SERVICE BULLETIN

MT97-001

FS5R30A AND RS5R30A TRANSMISSIONS DETENT HOLES ELIMINATED FROM ADAPTER PLATE

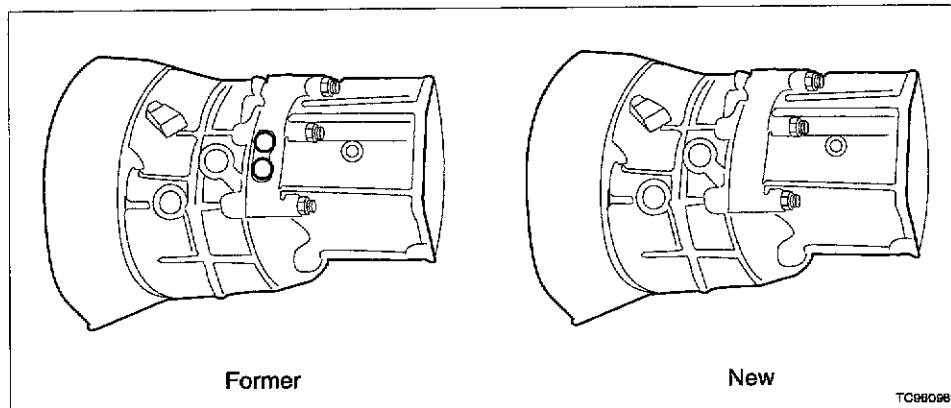
A new adapter plate has been implemented on the FS5R30A and RS5R30A transmissions. There are no detent holes or related components (check ball, spring and bolt) on the new adapter plate.

The function of the detent hole and its related components was to prevent the reverse shift fork from breaking. Beginning July 10, 1986, the reverse shift fork material was changed eliminating the need for the detent hole and the detent related components.

Except for the 1986.5 Truck, the new adapter plate can be used as a full replacement on all FS5R30A and RS5R30A transmissions. **Discard the original set of detent components from the adapter plate being replaced.**

For the 1986.5 Truck, **in addition to the new adapter plate replacement**, you must install a new reverse shift fork, P/N 32819-01G60.
